LENNAR MULTIFAMILY COMMUNITIES SPRING STREET NORTH BLOCK PUBLIC BENEFITS

SDC COMMENTS

AND RESPONSES

PUBLIC BENEFITS DIAGRAM

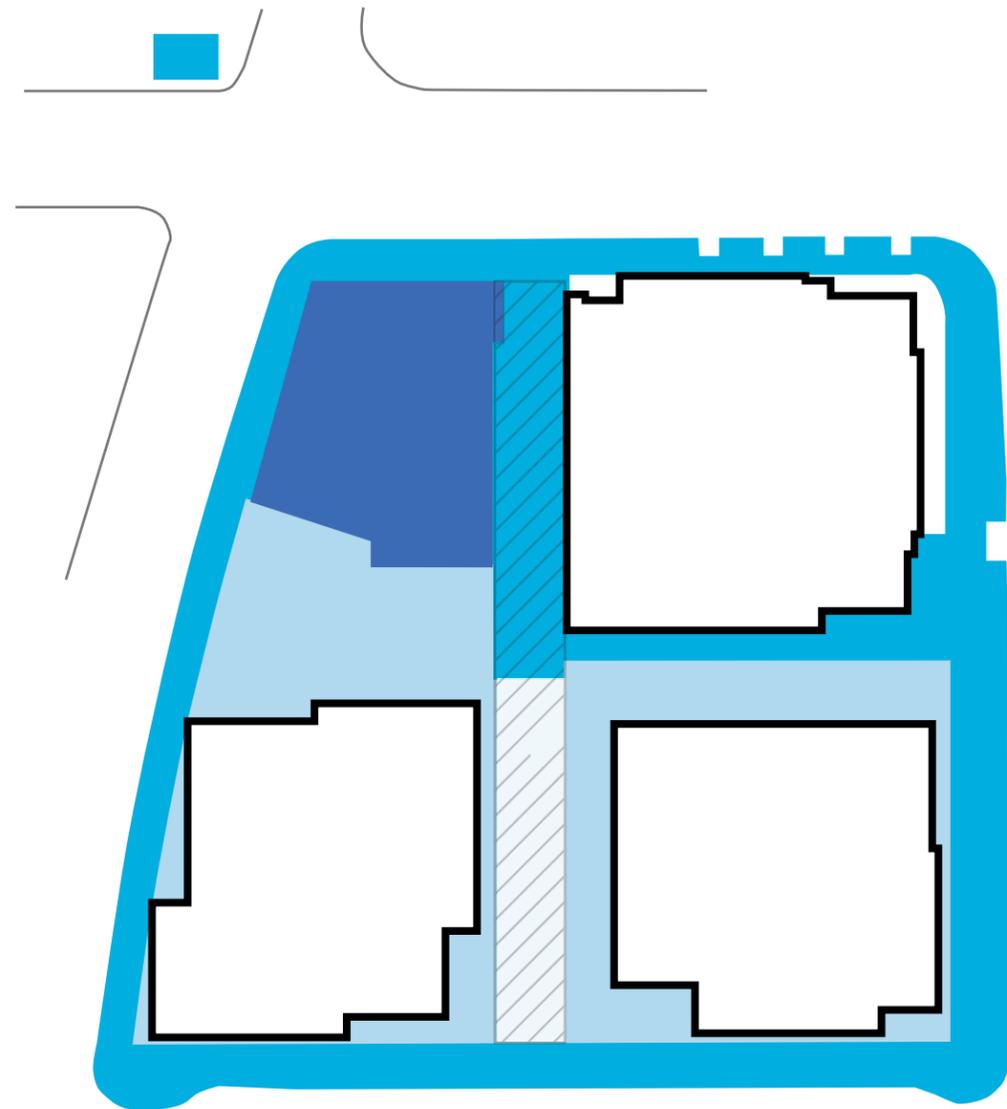
COMMENT 02

Provide clarity as to what open spaces are being considered for public benefit.

- Open Space for Public Benefits
- Improvements for Public Benefits
- Open Space for Residential Amenity, Restaurant
- Woonerf

1 - Public Plaza

2 - Town Hall Improvements

3 - ROW Improvements

4 - Freeway Park Connection

SPECIAL PAVING

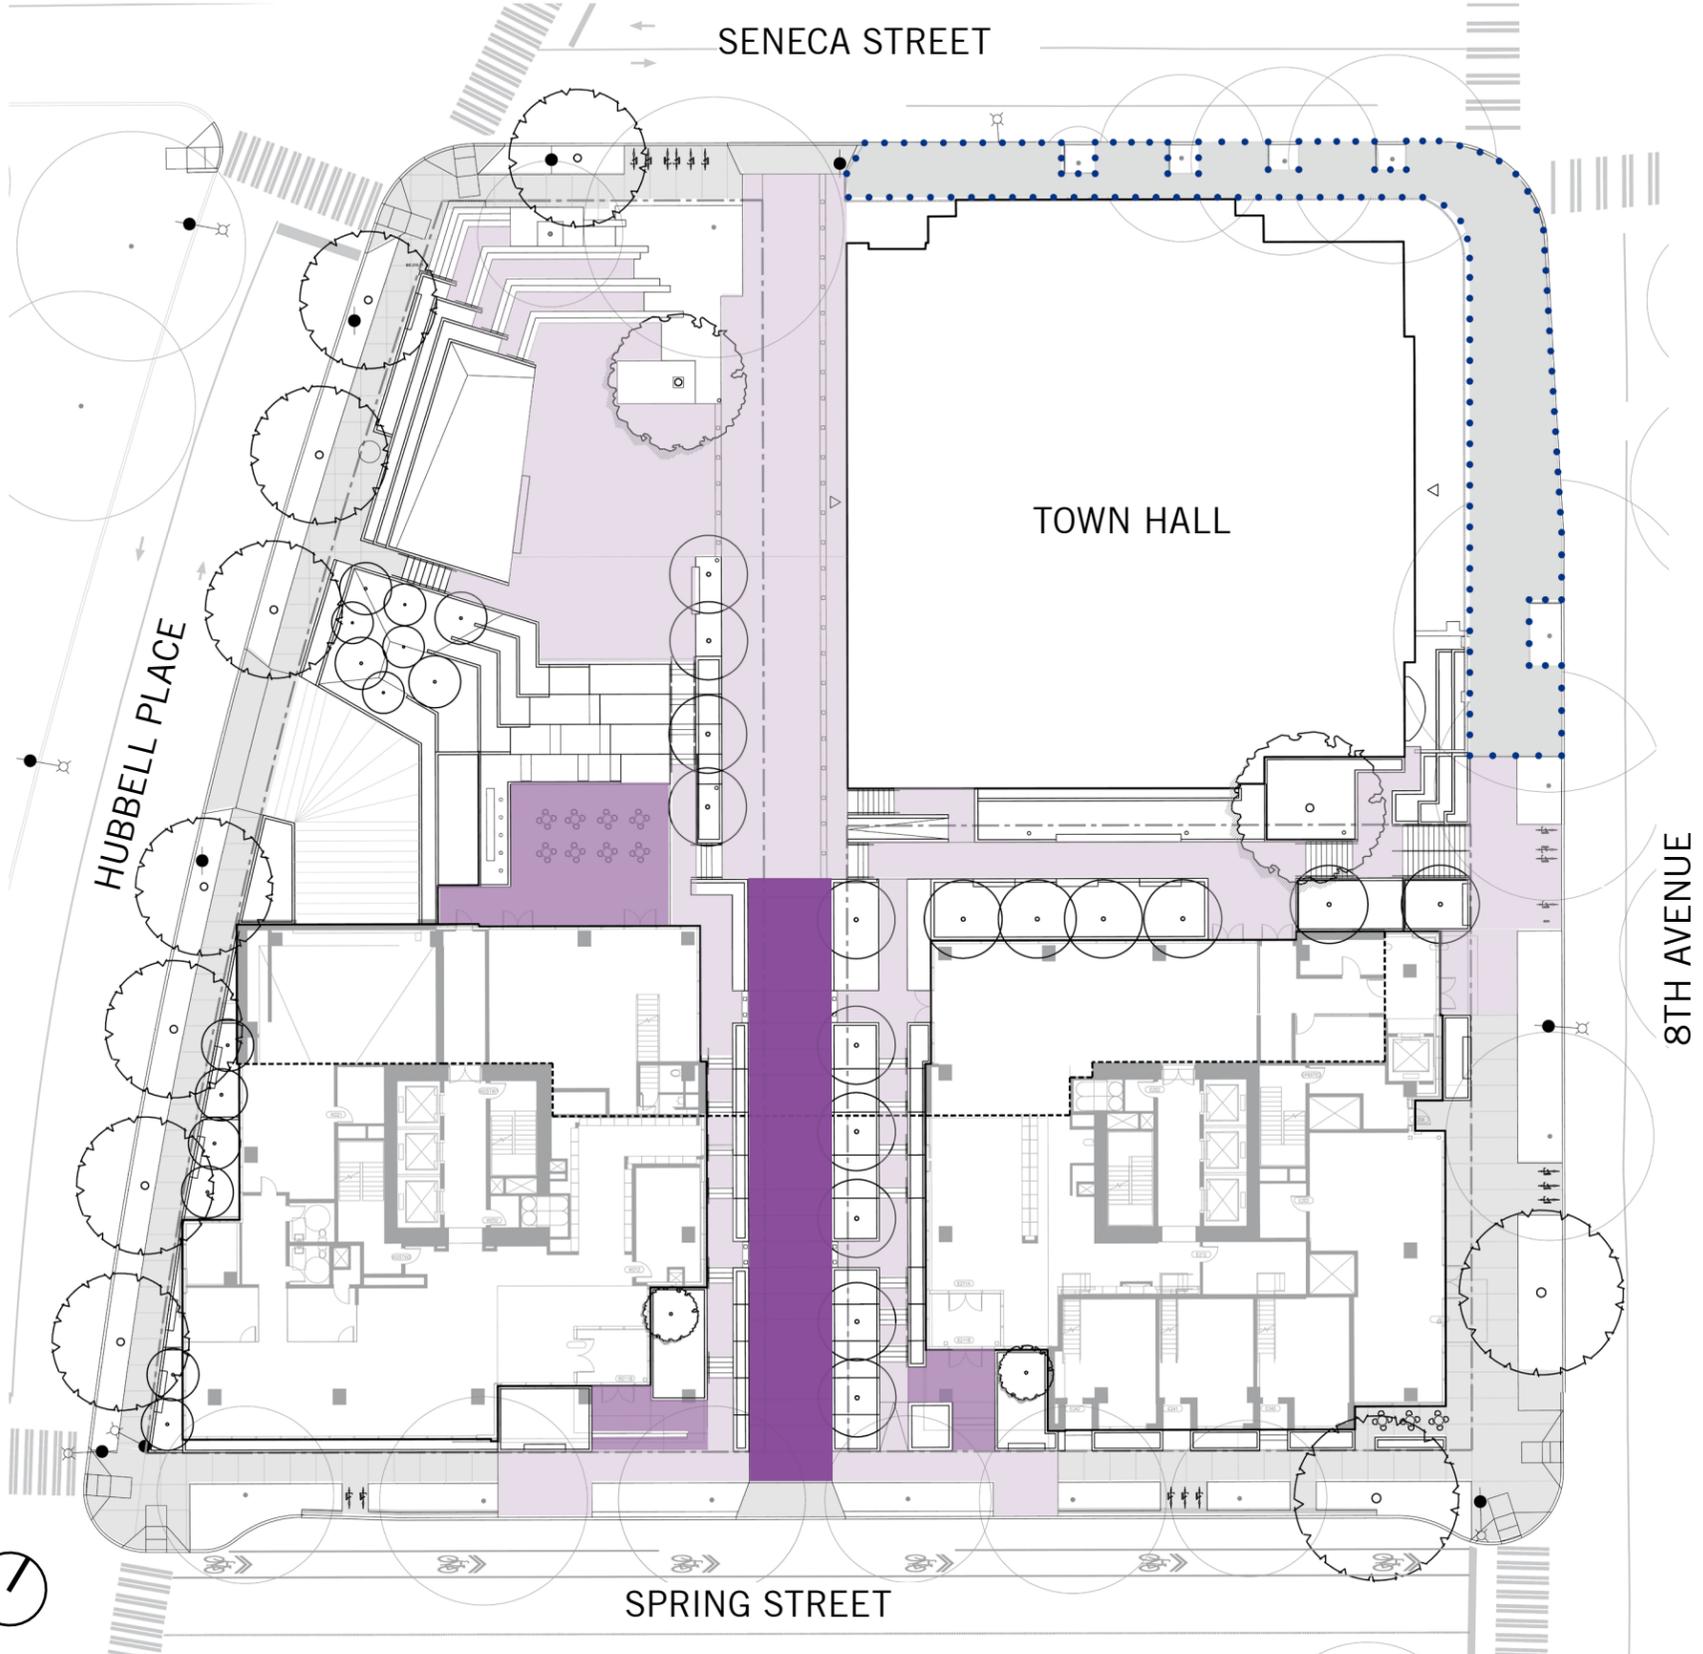
COMMENT 03

Provide information explaining why special paving should be considered a public benefit.

- concrete unit paving (7000 sqft)
- stamped concrete (100 sqft)
- CIP concrete sidewalk (2860 sqft)
- Total special paving (7100 sqft)**

OUTSIDE PUBLIC BENEFIT AREA

- concrete unit paving (1800 sqft)
- natural stone paving (1650 sqft)
- stamped concrete (1760 sqft)
- CIP concrete (3010 sqft)
townhall sidewalk agreement
- Total special paving (5210 sqft)**

SITE FURNISHING

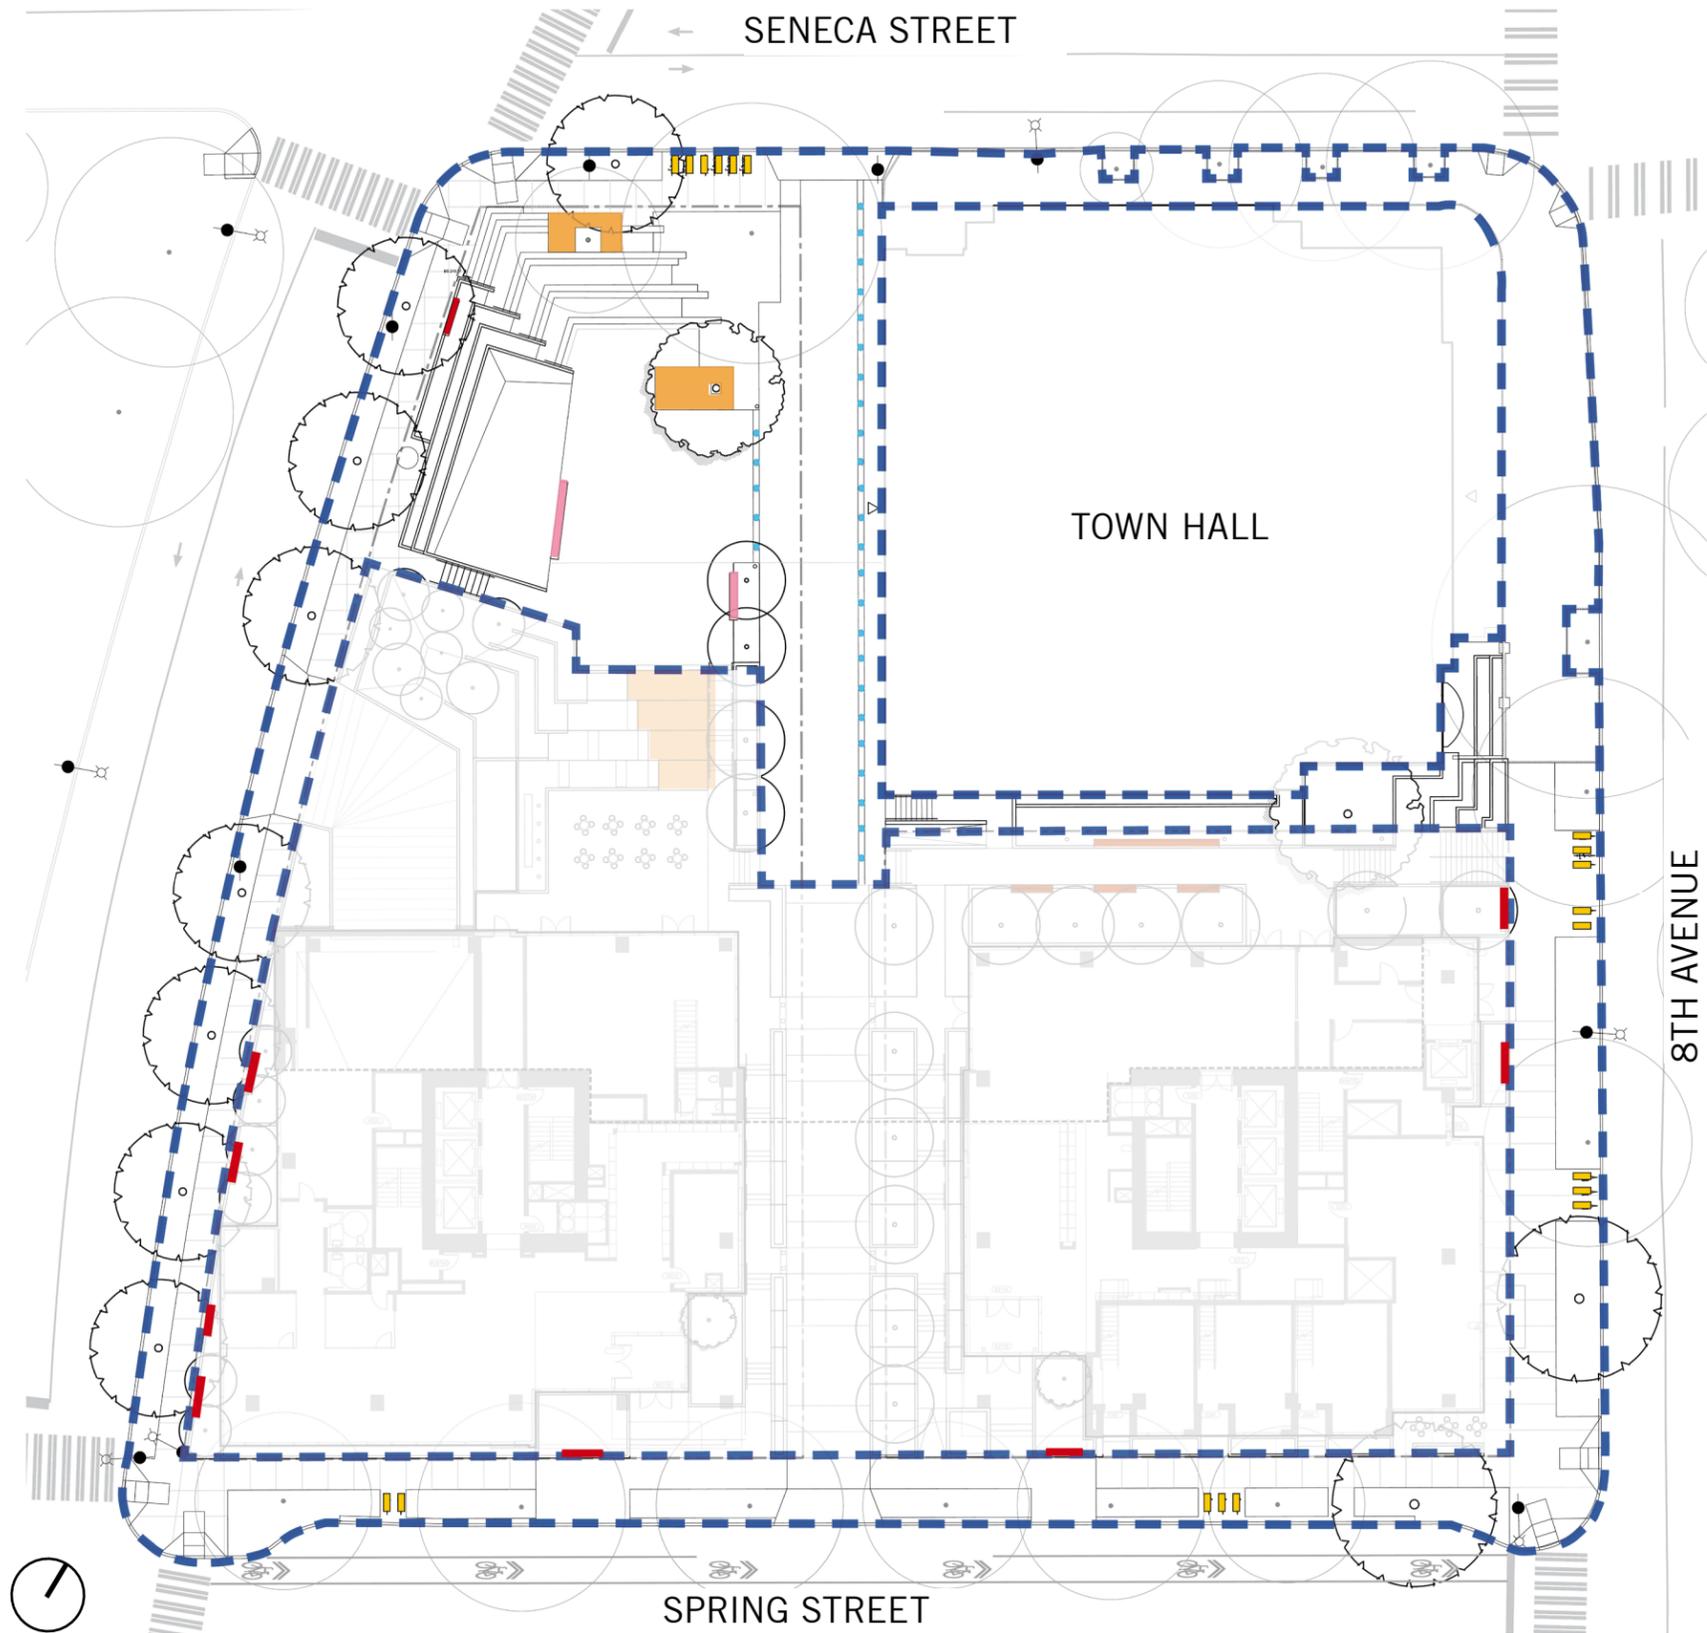
COMMENT 04

Provide information explaining why enhanced seating should be considered a public benefit.

PUBLIC BENEFIT AREA

- IPE wood top bench (85 lft)
- IPE wood seating platform (200 sqft)
- Floating Bench (2)
- Bike Racks (19)
- Bollards (29)

OUTSIDE PUBLIC BENEFIT AREA

- IPE wood top bench (49 lft)
- IPE wood seating platform (290 sqft)
